**Build a Better Bridge Faster
White Paper
Provided to Governors Christine O. Gregoire and John A. Kitzhaber, M.D.
By the members of the
CRC Urban Design Advisory Group
March 11, 2011**

G-001-001

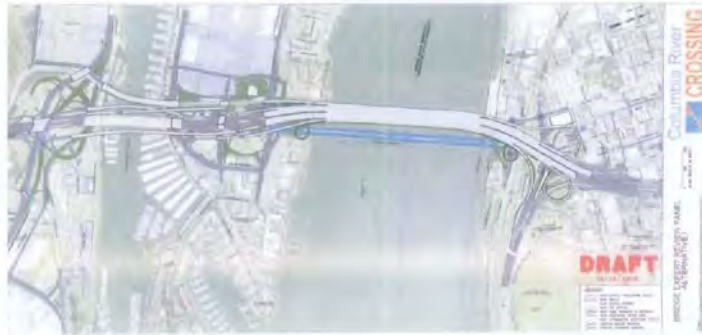
If the recommendation by the Bridge Review Panel to replace the Harbor Bridge (*Bridge Review Panel Final Report, p. 103*) was recognized, then there would need to be additional Island ramp reconfiguration. That would have likely impacted the Jantzen Super Center parking lot.

Without consideration of the Bridge Review Panel recommendation on the Harbor Bridge, Marine Drive and Hayden Island Interchanges, it is straightforward to hook up the cable-stayed bridge to the existing design of the ramps and absolutely keep the agreement with the Hayden Island Community and the Jantzen Beach Super Center.

For cost savings purposes, the project has elected to keep the North Portland Harbor bridges rather than replace them.
